South Texas Project Electric Generating Station P.O. Box 289 Wadsworth, Texas 77483

South Texas Project  
Units 1 and 2  
Docket Nos. STN 50-498, STN 50-499  
Response to Request for Additional Information Regarding  
Revised Request for Approval of an Alternative Approach for  
Containment Concrete and Tendon Surveillances (RR-ENG-37)

**SOUTH TEXAS PROJECT  
RESPONSE TO REQUEST FOR ADDITIONAL INFORMATION  
REGARDING CONTAINMENT TENDON SURVEILLANCE REQUIREMENTS**

Revised Figure 1: Trend Lines of Lift-Off Test Results (Years 1, 5, and 10)

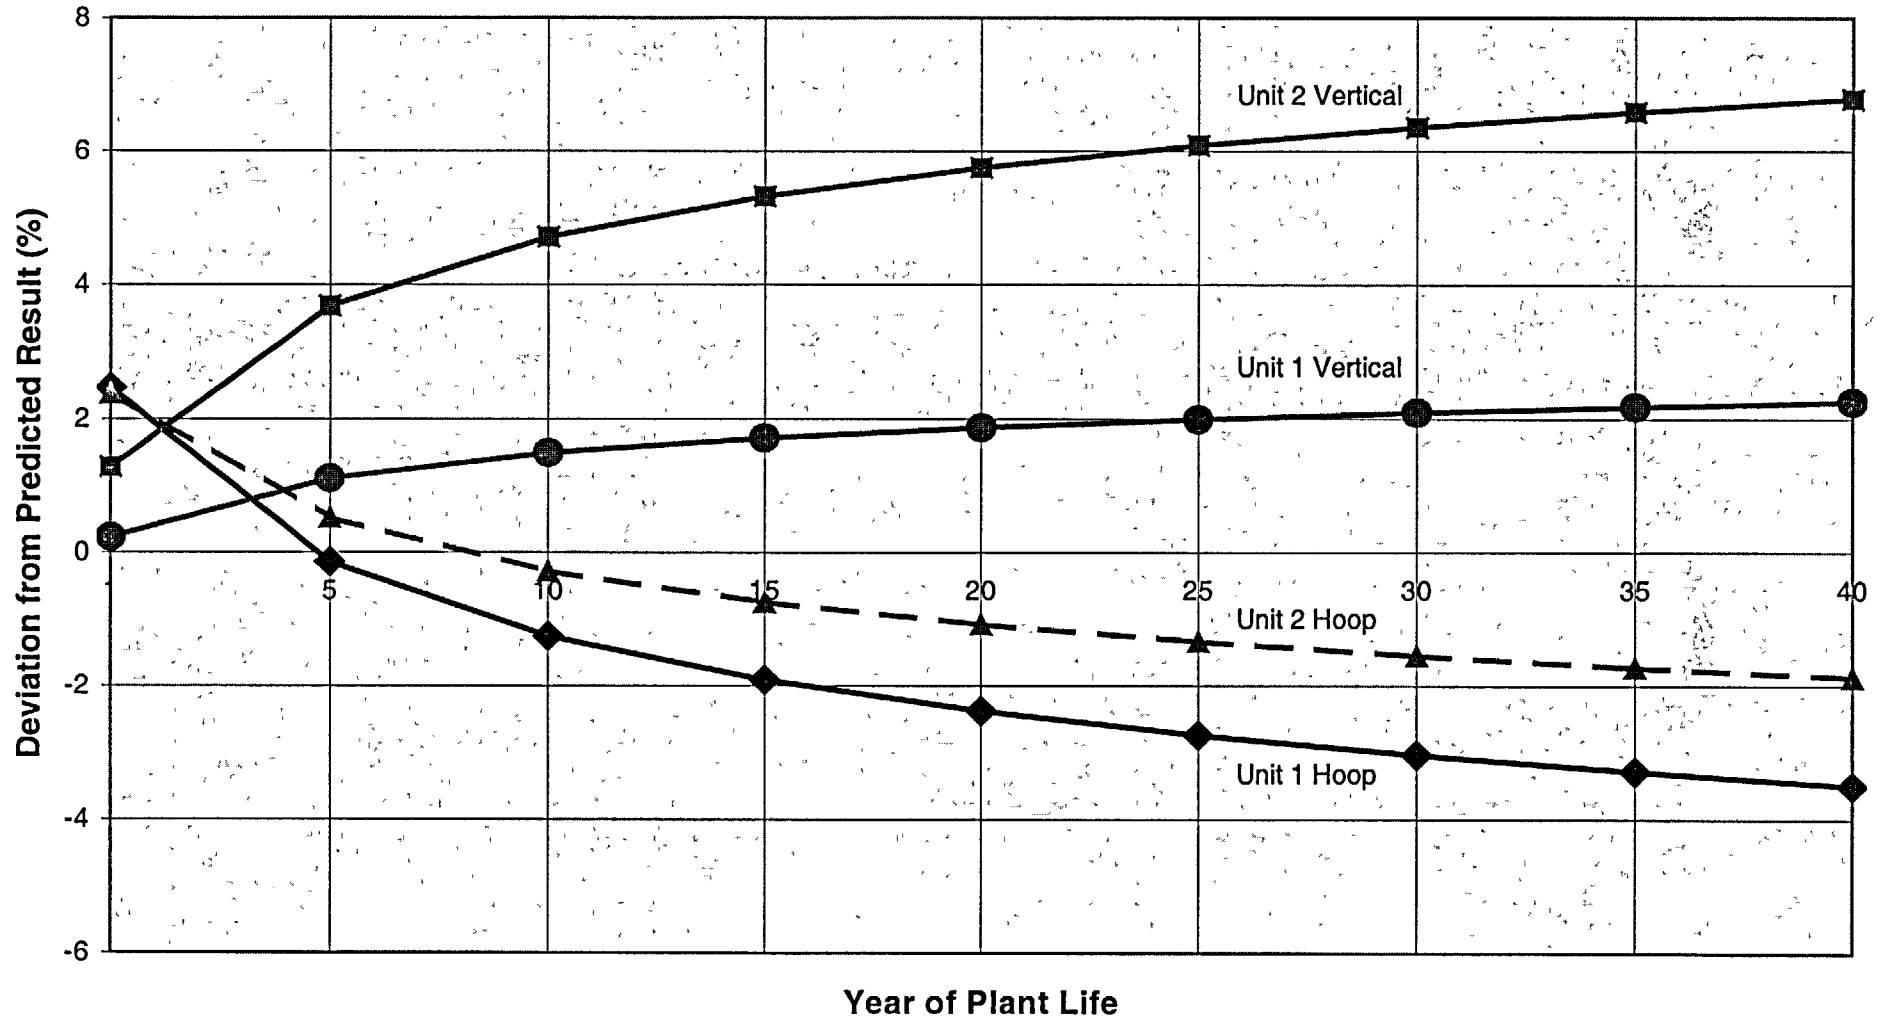
*In reviewing the information in Figure 1 and Tables 1 and 2, it is unclear what the actual measured and predicted tendon forces are. The licensee is requested to provide Tables showing actual measured pre-stressing forces for each Unit in each direction together with the forces at installation, elastic shortening losses, and slippage, if any, for the tendons selected during each prior inspections.*

*In the Figure, the licensee is requested to show:*

- (1) The trend lines (separately, for each Unit, and for U and hoop tendons) based on the inspections performed,*
- (2) Actual measured forces as points above and below the trend lines, and*
- (3) Predicted average tendon forces at 40 years.*

As read from top to bottom, respectively, on the right side of Figure 1, the four lines are:

- Unit 2 verticals (inverted "U"),
- Unit 1 verticals (inverted "U"),
- Unit 2 horizontals (hoop), and
- Unit 1 horizontals (hoop).

Tendon loss is typically presented on a semi-log plot, with prestress loss being linear with the log of time. STP prepared Figure 1 using a standard linear scale, resulting in nonlinear trend lines. The labels on the revised Figure 1 included with this response have been enhanced for greater clarity. (There is no change to the data presented in the figure.) Figure 2 has been added to show the same trends against the log of time.

The figures show *percent deviation* from the predicted value on the vertical axis. Although the request was to add the *actual measured forces* and end-of-life predicted average forces to the figure, the South Texas Project believes this information is more appropriately shown in the tables provided.

The South Texas Project believes that the information shown in revised Figure 1, Figure 2, and provided in the supplementary tables, while slightly different from the staff's request, meets the intent of the RAI.
